**RESPONSES TO PUBLIC COMMENTS ON  
NUREG-2224, “DRY STORAGE AND TRANSPORTATION OF  
HIGH BURNUP SPENT NUCLEAR FUEL,  
DRAFT REPORT FOR COMMENT”**

Division of Fuel Management  
Office of Nuclear Material Safety and Safeguards  
U.S. Nuclear Regulatory Commission  
Washington, DC 20555-0001

On August 9, 2018, the U.S. Nuclear Regulatory Commission (NRC) issued for public comment NUREG-2224, "Dry Storage and Transportation of High Burnup Spent Nuclear Fuel, Draft Report for Comment" (83 FR 39475). NUREG-2224 provides technical background information applicable to high burnup spent nuclear fuel (HBU SNF), provides an engineering assessment of recent NRC-sponsored mechanical testing of HBU SNF, and proposes example approaches for use in potential licensing and certification applications for dry storage and transportation of HBU SNF. The initial comment period closed on September 24, 2018. In response to a request from numerous public interest groups, the comment period was re-opened on October 10, 2018 for a further 30 days (83 FR 50965). The second comment period closed on November 9, 2018. Comments on this proposed technical report are available electronically at the NRC's electron

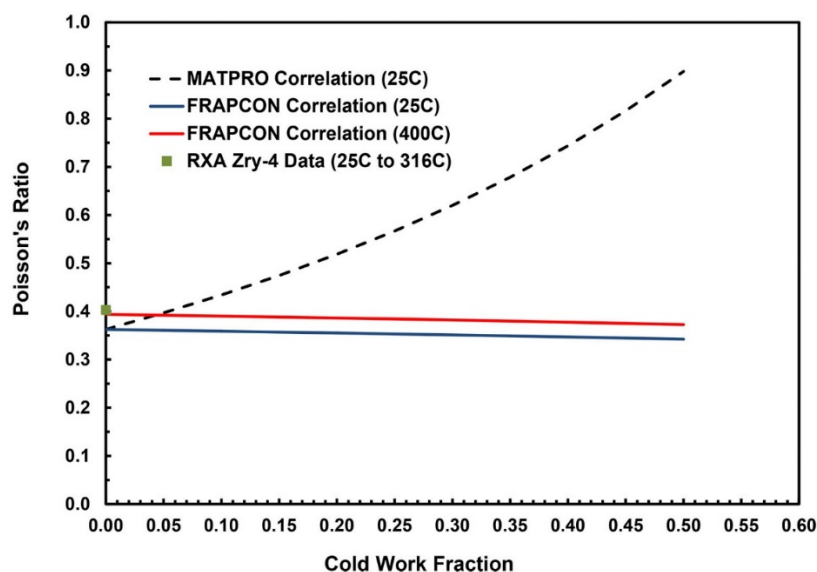
*The commenter stated: “Mechanical Properties Data for Zr-based Cladding Alloys: The two Geelhood et al. references provide adequate guidance to the applicant for the mechanical properties of Zircaloy-2 (Zry-2), Zircaloy-4 (Zry-4) and to some extent ZIRLO. Both references*

contain the same correlation for Young's modulus ( $E$ ), which is a function of cold-work fraction, temperature, fast fluence, and excess oxygen (not relevant).

Only the 2nd reference (Geelhood et al, 2013 – please correct to 2014 in text and reference list) contains correlations for a much needed second elastic constant, which in this case is the shear modulus ( $G$ ). For elastic analyses of isotropic materials, most stress-strain relationships are written in terms of  $E$  and Poisson's ratio ( $\nu$ ), which is generally in the range of 0.2 to 0.4 for metals and always  $<0.5$ . Reviewers of license applications should be aware that  $E$  and  $G$  correlations used in FRAPCON-3.5, FRAPCON-1.5, and MATPRO are compared in Geelhood et al, 2014. Although not pointed out by the authors, the MATPRO correlation for  $G$  has an incorrect dependence on cold-work fraction ( $CW$ ) that leads to unrealistic values of  $\nu = E/(2G) - 1$ . The FRAPCON correlation for  $G$  appears to be correct. The figure below shows the comparison among MATPRO-calculated  $\nu$ , FRAPCON-calculated  $\nu$ , and  $\nu$ -data for recrystallized-annealed (RXA,  $CW = 0$ ) Zry-4 in the 24°C–316°C temperature range [1]. The FRAPCON correlations for  $E$  and  $G$  give  $\nu = 0.37 \pm 0.02$  in the 25°–400°C temperature range with no significant variation with  $CW$ , temperature, and fast fluence.
